CITY OF NAPOLEON - BUILDING DEPARTMENT
 255 West Riverview Avenue, Napoleon, Ohio 43545 - 419-592-4010

Permit No. 845 - 77 Issued 10/17/77
date

RESIDENTIAL PLAN CORRECTION SHEET

ADDENDUM to Permit No. 845-77
Owner L. WAEFFELMAN
Location 550 EUCLID AVE.

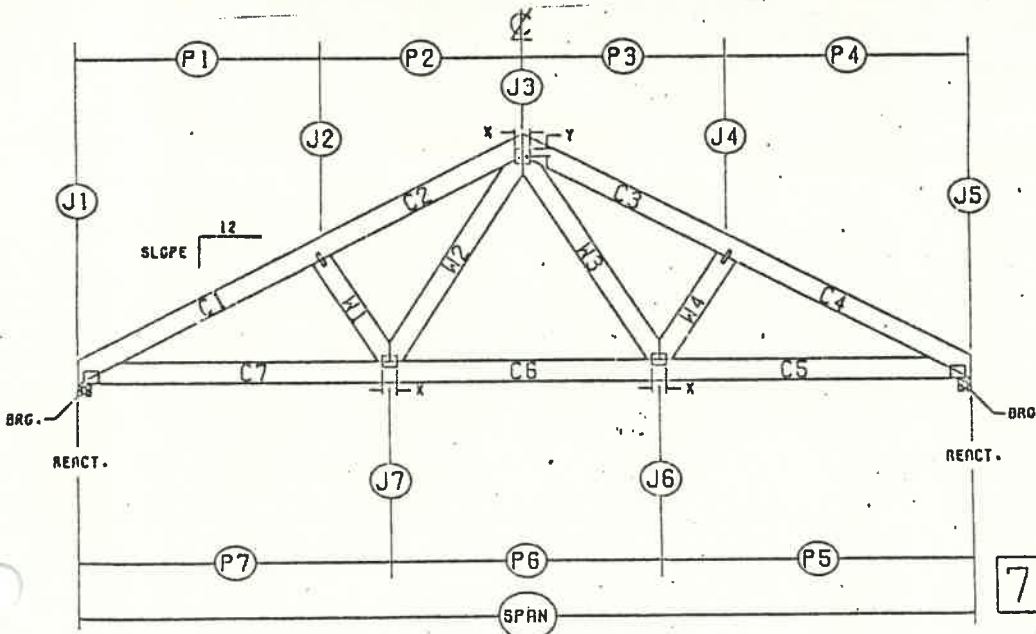
Plan Approval

By *Bob* Date 11-7-77
